STATE OF NORTH CAROLINA
DEPARTMENT OF TRANSPORTATION

SUBJECT: Triangle Expressway Southeast Extension (Complete 540) from NC 55 Bypass in Apex to US 64/264 (I-87) in Knightdale, Wake and Johnston Counties; Federal Aid No. STP-0540(19), STP-0540(20), and STP-0540(21); WBS Nos. 37673.1.TA1, 35516.1.TA1, and 35517.1.TA1; STIP Project Nos. R-2721, R-2828, and R-2829

Subject: Request for Modification on R2829B, Complete 540, Federal Aid Project No. 050047; Permit sites 32/33; Permit Mod Request #27

Revised SPECIAL CONDITIONS

PERMIT DRAWING SHEET 76 OF 112

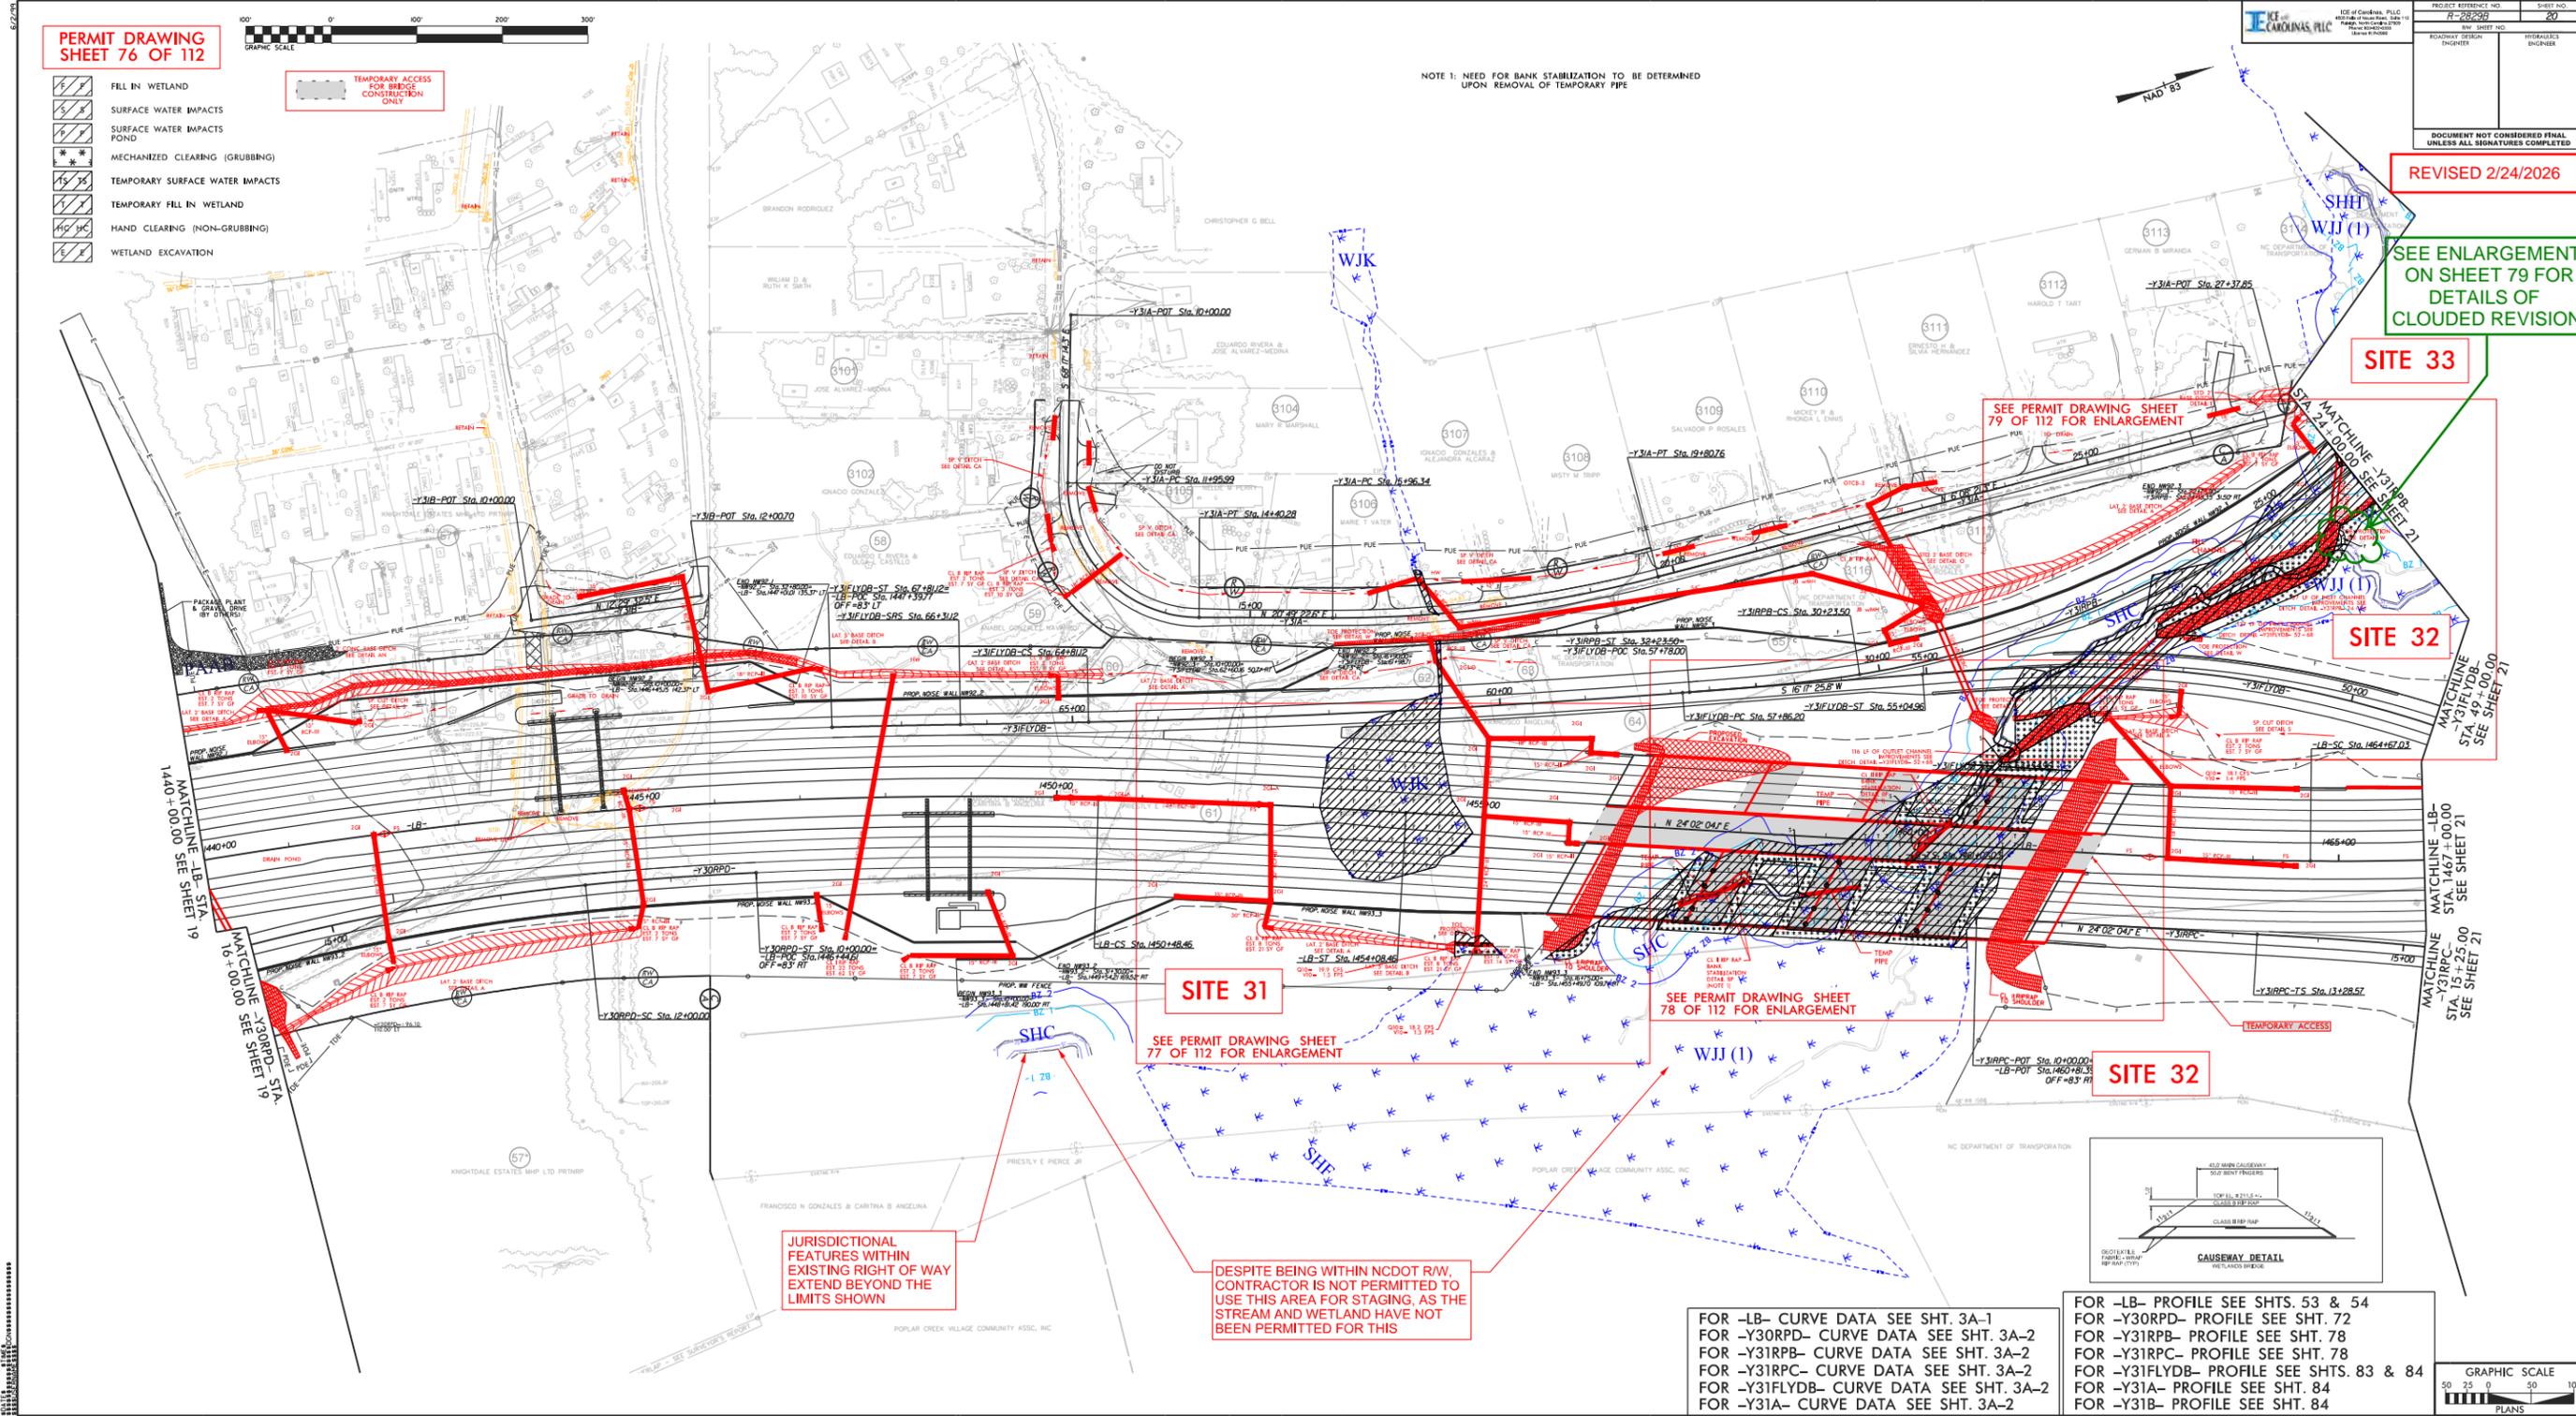
SEE ENLARGEMENT ON SHEET 79 FOR DETAILS OF CLOUDED REVISION

PERMIT DRAWING SHEET 79 OF 112

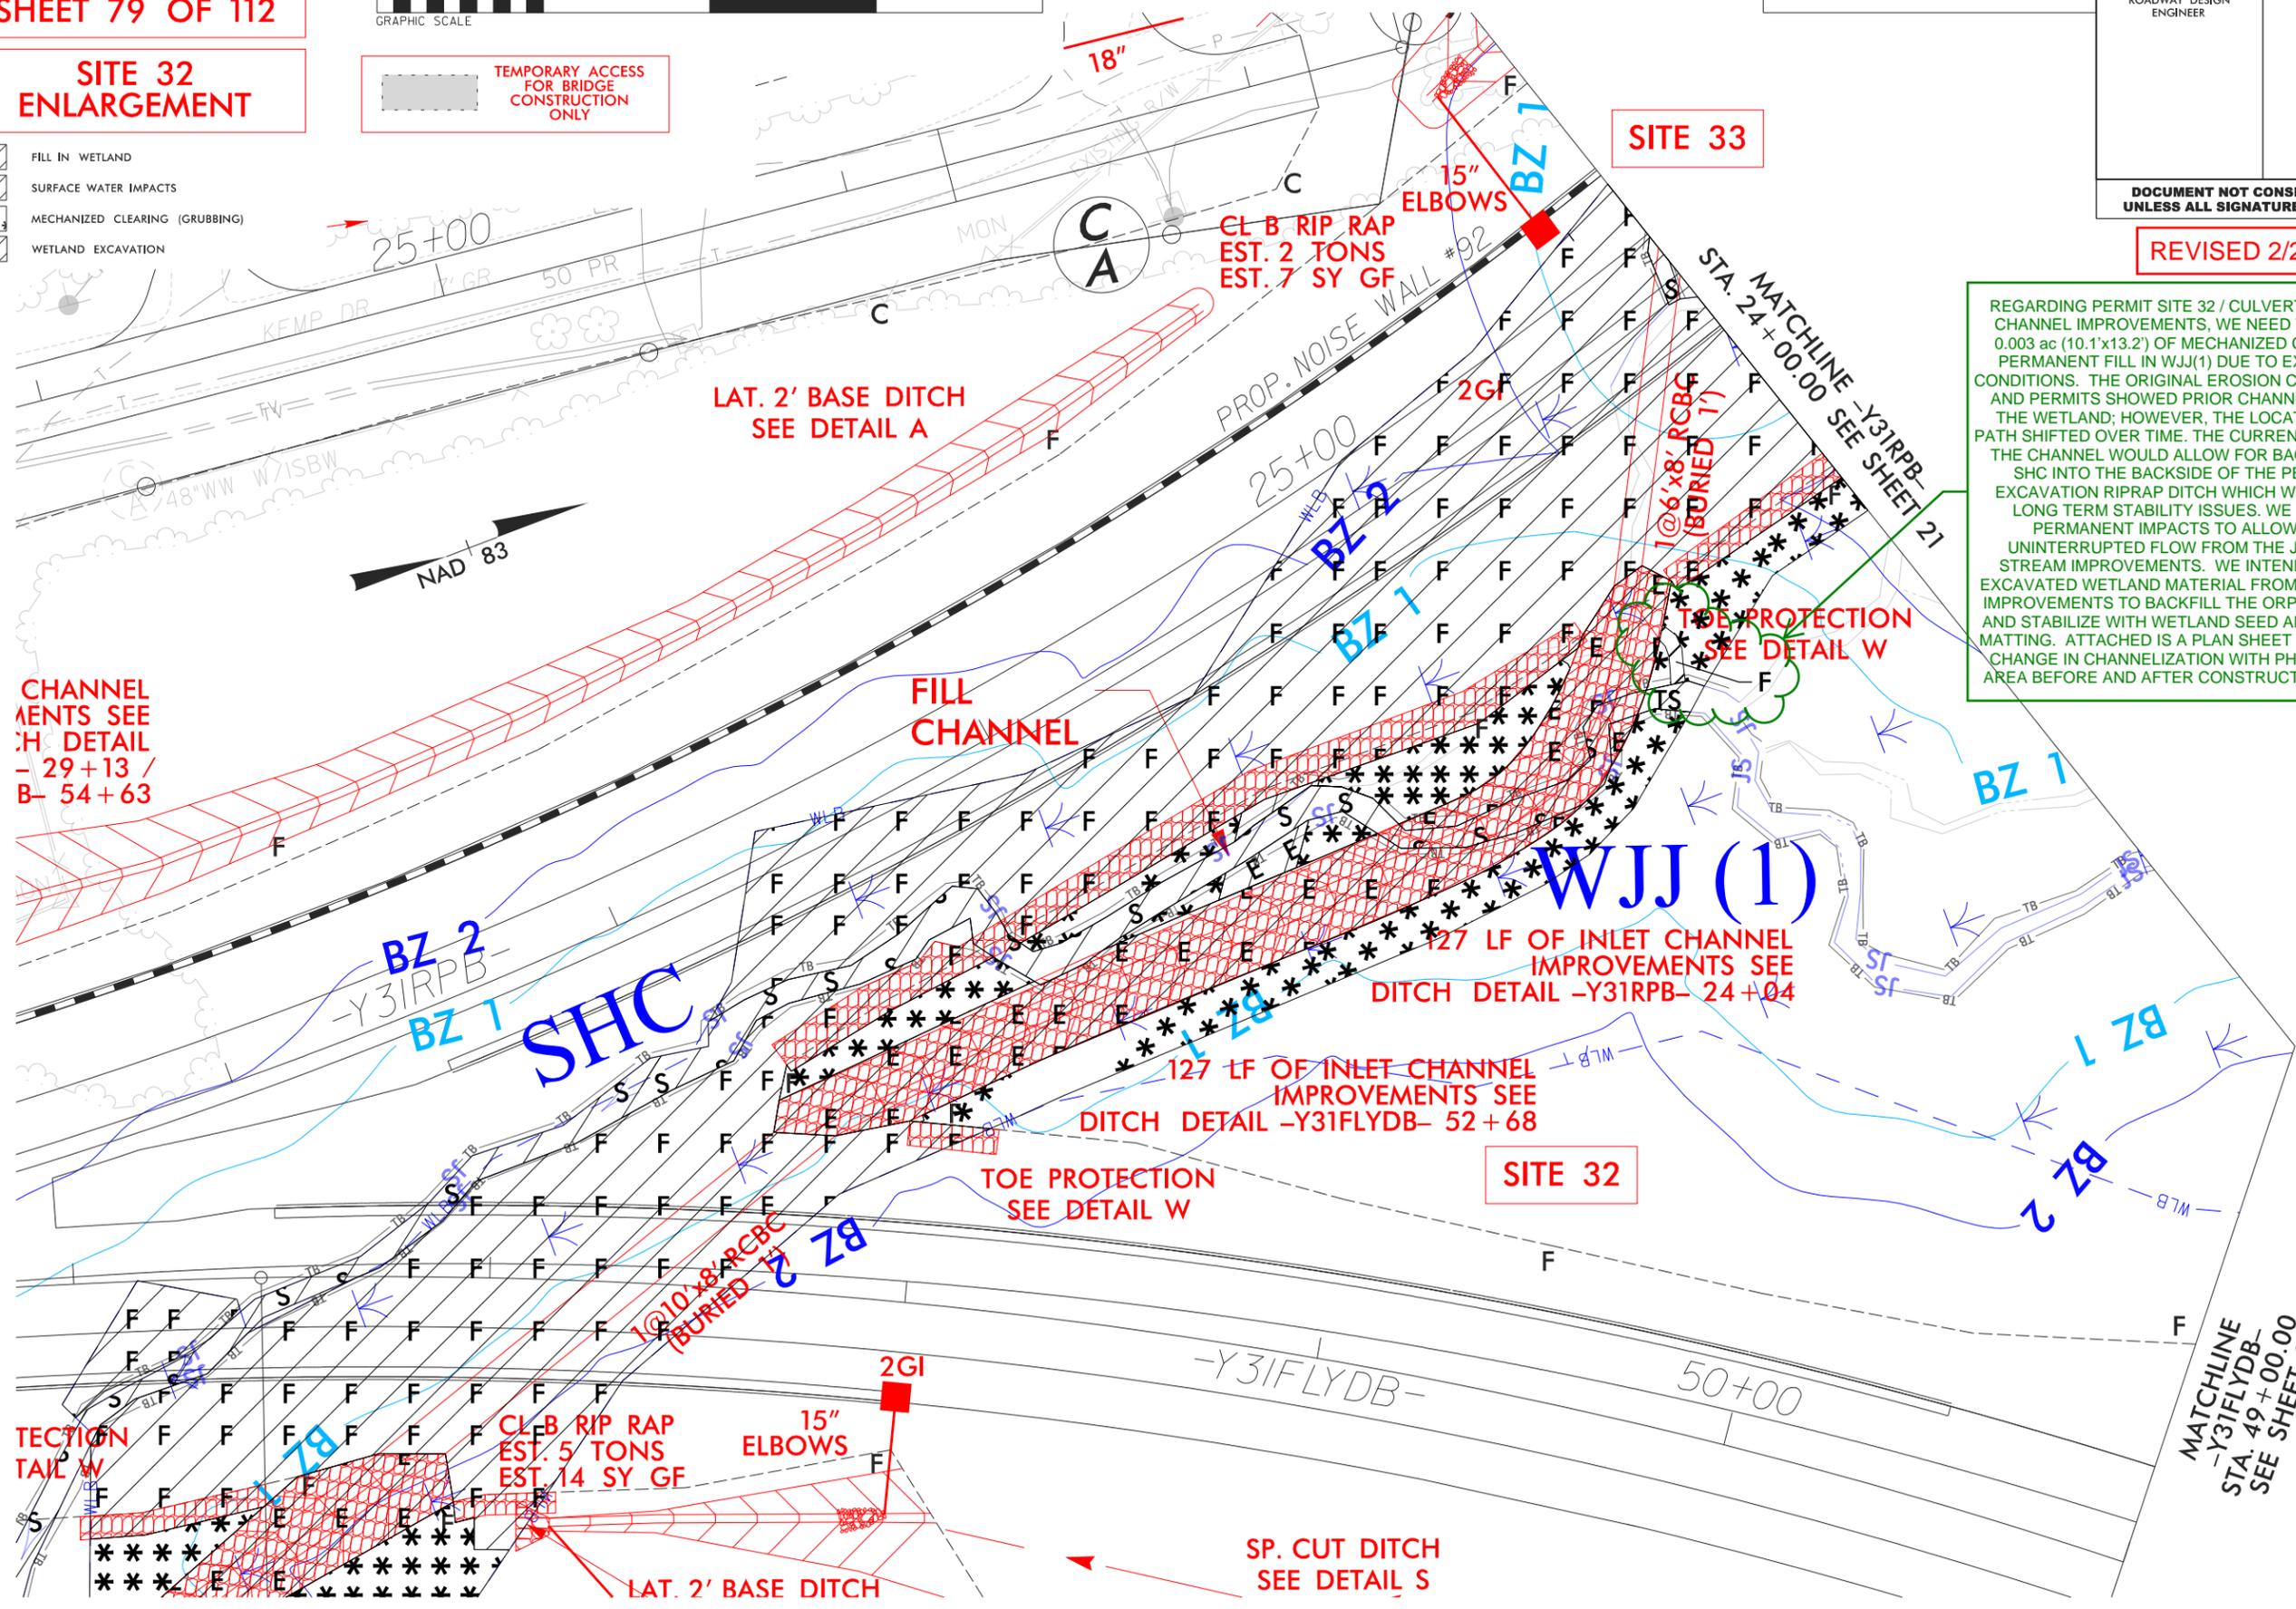
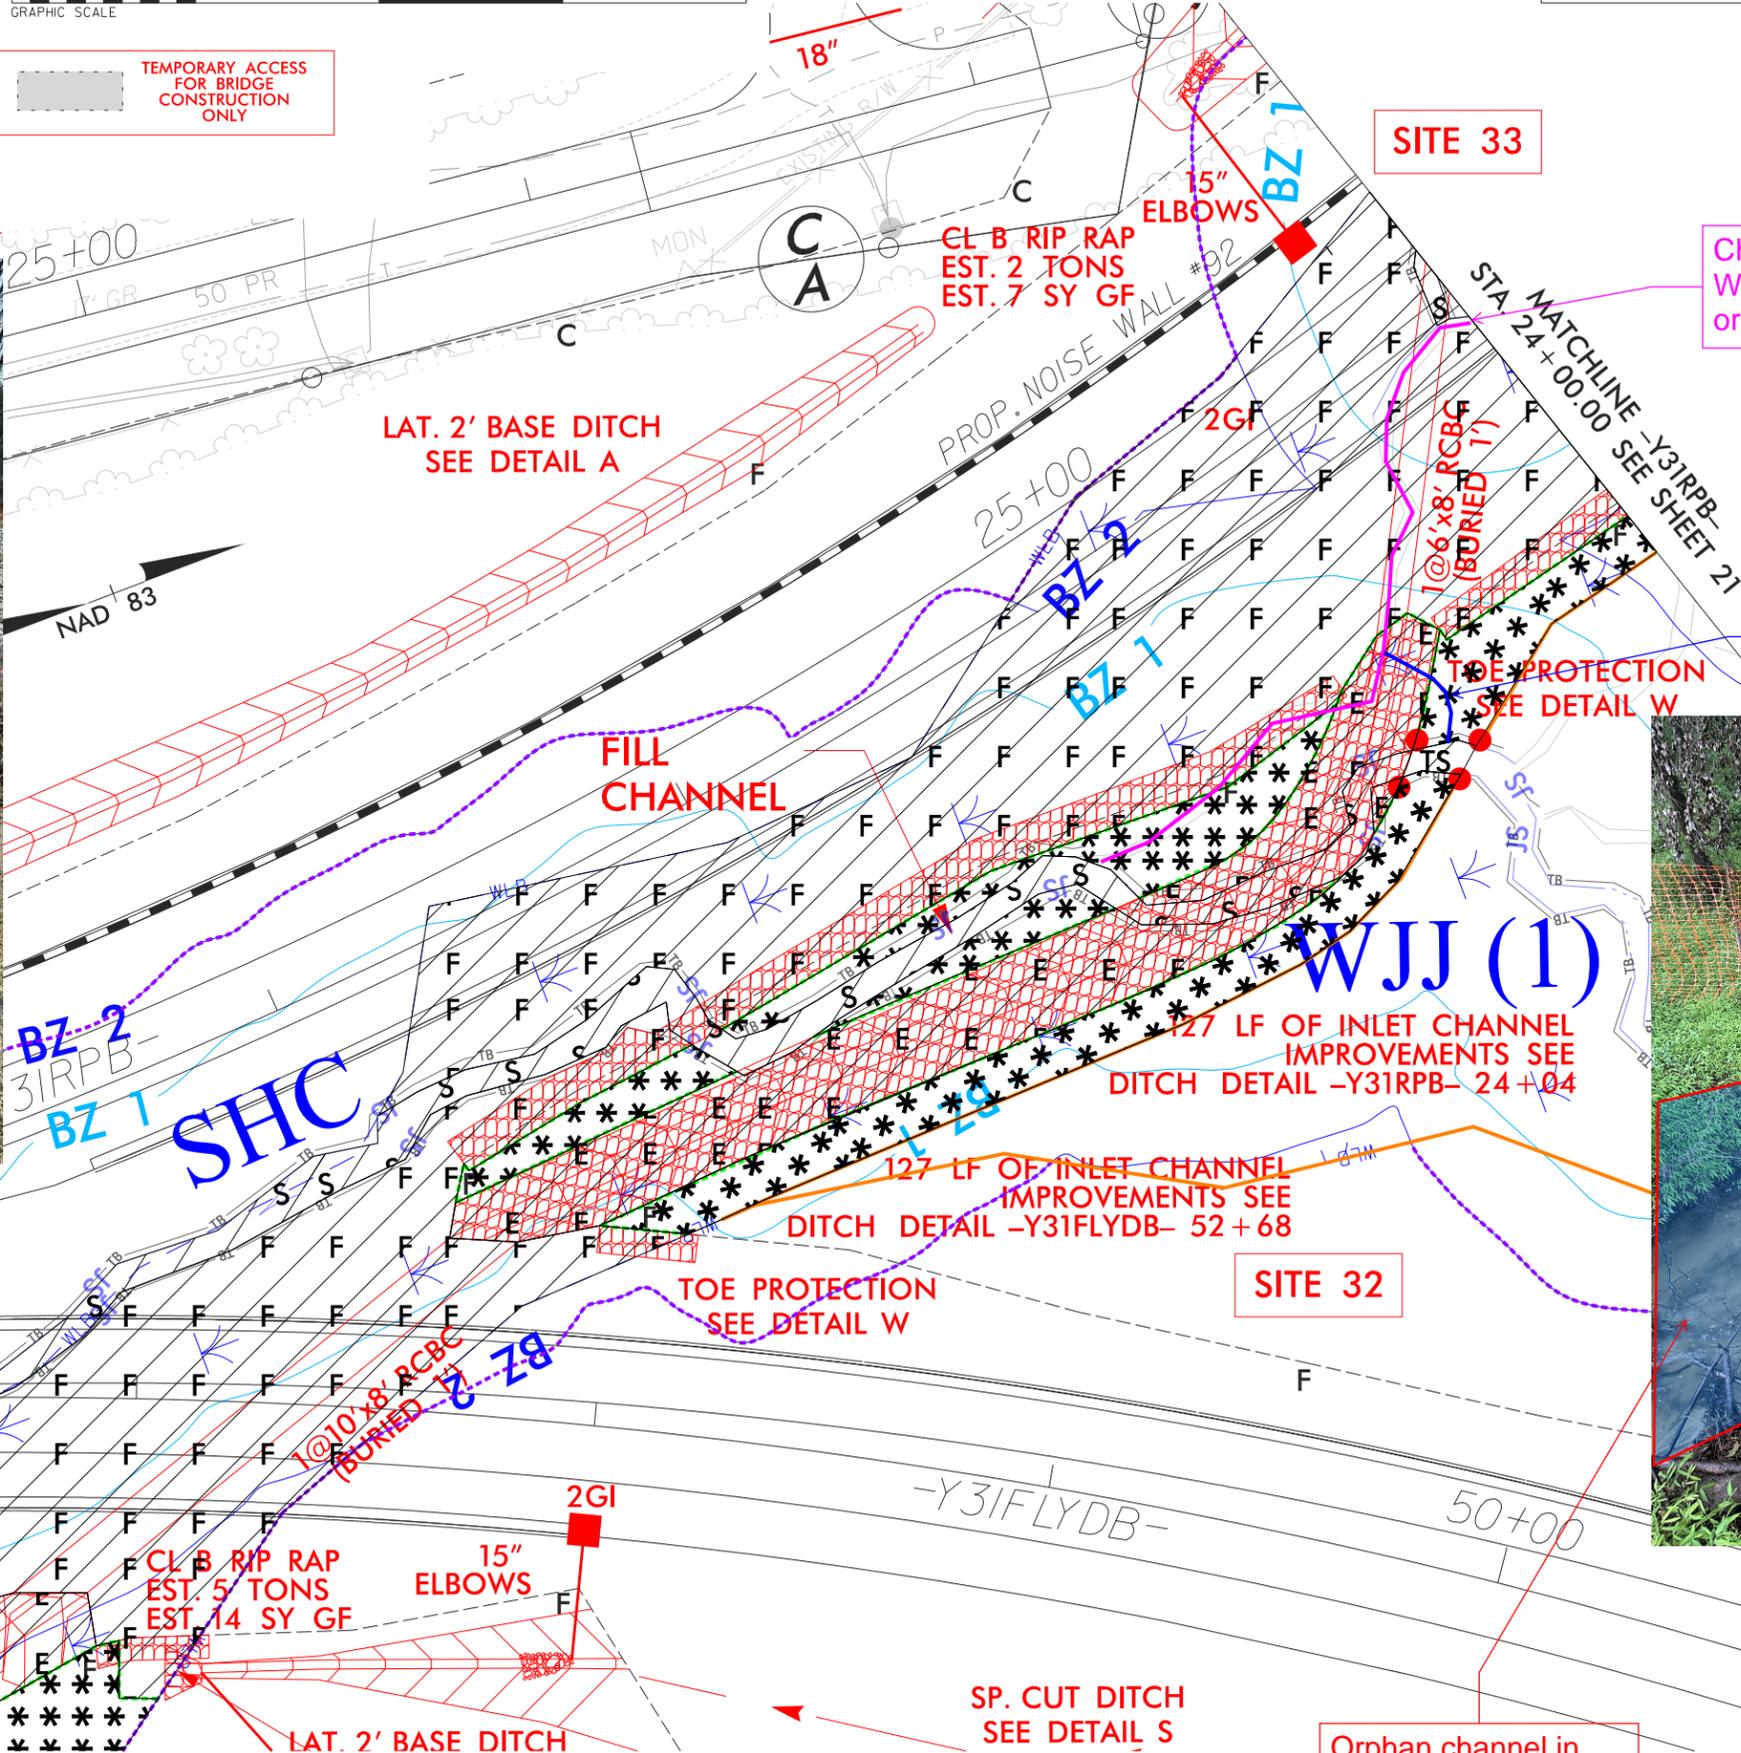
REGARDING PERMIT SITE 32 / CULVERT C11 OUTLET CHANNEL IMPROVEMENTS, WE NEED TO CONVERT 0.003 ac (10.1'x13.2') OF MECHANIZED CLEARING TO PERMANENT FILL IN WJJ(1) DUE TO EXISTING SITE CONDITIONS. THE ORIGINAL EROSION CONTROL PLANS AND PERMITS SHOWED PRIOR CHANNELIZATION OF THE WETLAND; HOWEVER, THE LOCATION OF THIS PATH SHIFTED OVER TIME. THE CURRENT LOCATION OF THE CHANNEL WOULD ALLOW FOR BACKFLOW FROM SHC INTO THE BACKSIDE OF THE PERMANENT EXCAVATION RIPRAP DITCH WHICH WOULD CAUSE LONG TERM STABILITY ISSUES. WE WILL NEED PERMANENT IMPACTS TO ALLOW FOR AN UNINTERRUPTED FLOW FROM THE JS INTO THE STREAM IMPROVEMENTS. WE INTEND TO UTILIZE EXCAVATED WETLAND MATERIAL FROM THE CHANNEL IMPROVEMENTS TO BACKFILL THE ORPHAN CHANNEL AND STABILIZE WITH WETLAND SEED AND COIR FIBER MATTING. ATTACHED IS A PLAN SHEET SHOWING THE CHANGE IN CHANNELIZATION WITH PHOTOS OF THE AREA BEFORE AND AFTER CONSTRUCTION STARTED.

Current site condition, portion of WJJ(1) needing fill

Channelization of WJJ(1) shown on original plans

Convert 0.003 ac of Wetland Impact from Mechanized Clearing to Permanent Fill. Impact is already mitigated for and no change to amount of total impacts is proposed. This is for Site 32 on section R-2829B of the Complete 540 Project.
